SAFETY EVALUATION REPORT
PLANT HATCH UNIT-2

In a letter dated October 4, 1982 from J. T. Beckham of Georgia Power Company (the licensee) to the Director of NRR, a change to Technical Specification Figures 3.2.3-1 and 3.2.3-2 for Plant Hatch unit 2 was requested. The change would increase the operating limit minimum critical power ratio (OL-MCPR) which is based upon analysis of abnormal operational occurrences.

τ MCPR LIMIT FOR 8XSR FUEL AT RATED FLOW
FIGURE 3.2.3-1

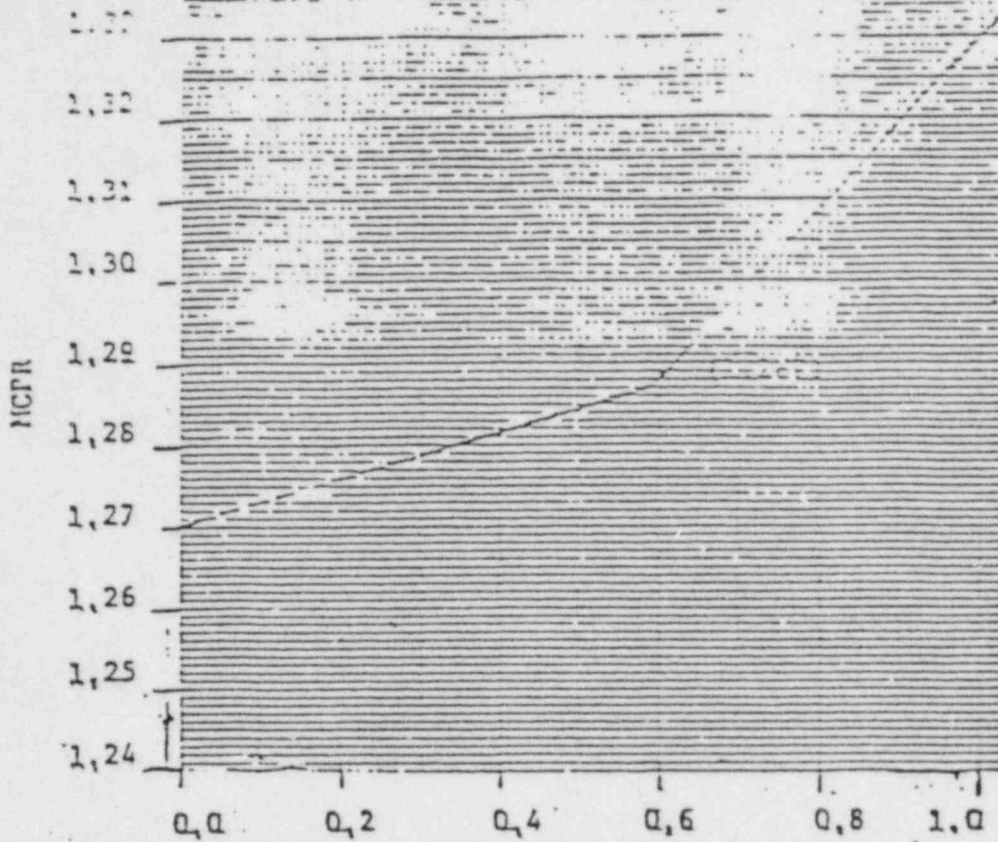
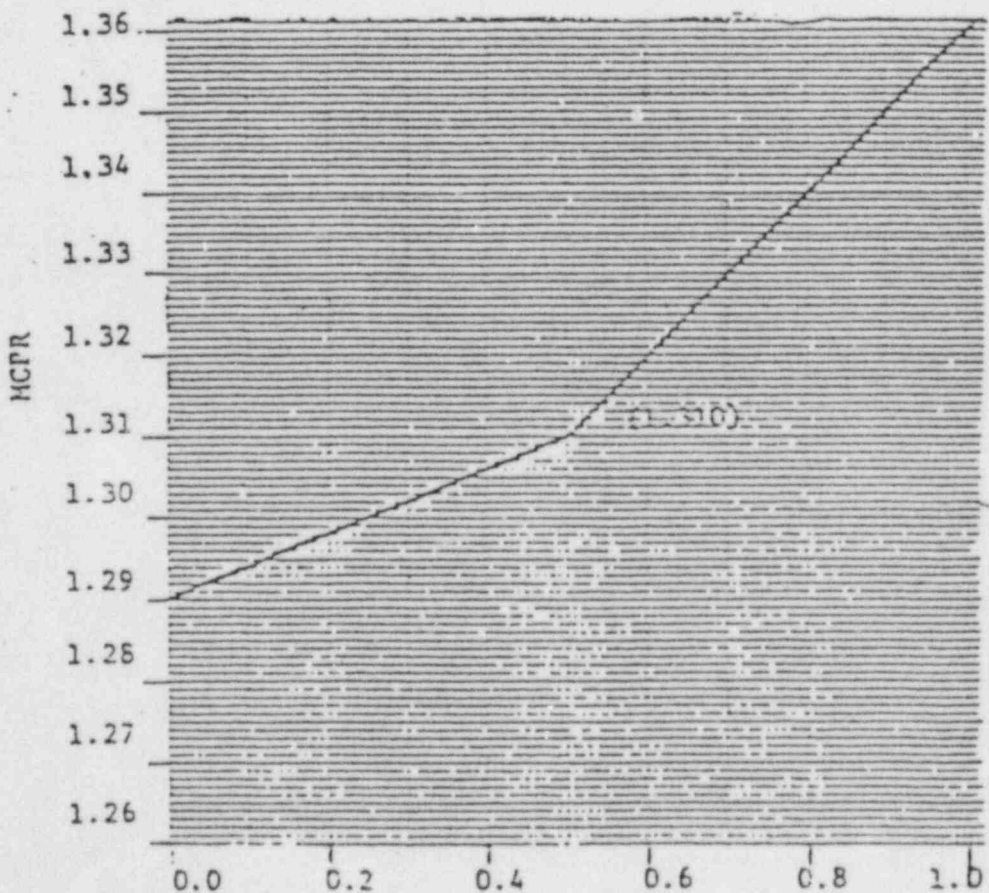
The licensee has requested this change to correct an error detected in the reload analysis which had been submitted to the staff in March, 1982, and was used to determine the present OL-MCPR specification. General Electric Company discussed the impact of the error in a letter dated June 8, 1982 from H.C. Pfefferlen (GE) to D.G. Eisenhut (NRC). The nature of the error was such that an operational transient occurring near the end-of-cycle could result in a violation of the MCPR safety limit if the plant was operating at the technical specification limit at the time of the transient. The plant is currently operating at an OL-MCPR which reflects the corrected analysis and is more restrictive than required by the present specification. The proposed change will conservatively revise the OL-MCPR based upon corrected analyses.

maximum flow event is the most limiting transient. The OL-MCPR for P8x8R fuel must be ≥ 1.29 , and for 8x8R fuel the OL-MCPR must be ≥ 1.27 . The exact value is determined from the attached Figures 3.2.3-1 and 3.2.3-2 and depends upon measured scram times as defined in specification 3/4.2.3.

We have reviewed the Technical Specification change requested by the licensee. We note that for the limiting event, feedwater controller failure to maximum demand, credit is assumed for operation of the high water level (L8) trip and the turbine bypass system. Accordingly, we require that technical specifications be included to ensure the operability of these systems. (Attachment 1 is a sample specification which we have found acceptable for other plants).

With the addition of technical specifications for the turbine bypass system and the L8 trip, we find that the technical specification change proposed by the licensee is acceptable. This conclusion is based upon our review of the licensee's submittal which indicates that the proposed action does not:

FIGURE 1 : ILLUSTRATION OF ALLOWABLE RCS TEMPERATURE VS. REQUIRED BORON CONCENTRATION DURING A COOLDOWN

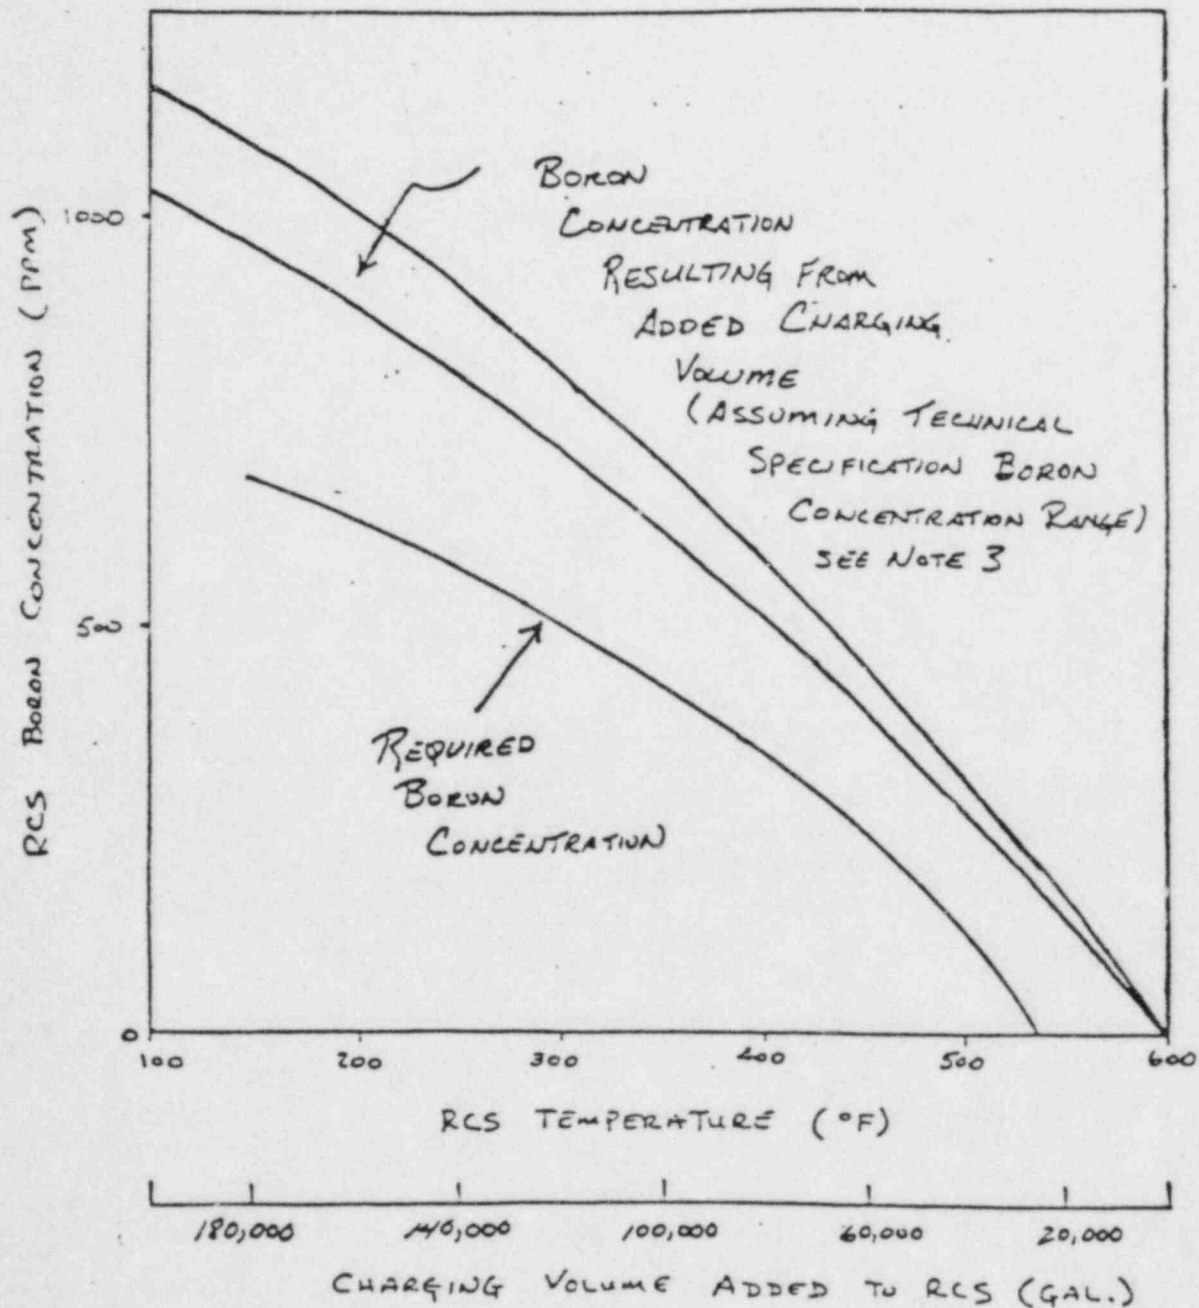
Figure 1, RCS temperature versus required boron concentration during a cooldown, illustrates how a minimum required boron concentration can be determined to maintain a given shutdown margin during a cooldown. This figure provides the operator with a valuable tool and an additional aid in maintaining reactivity control. Although shutdown margin is not necessary to verify reactivity control, it would be useful in the event of an unexpected cooldown while controlling the plant from outside the control room.
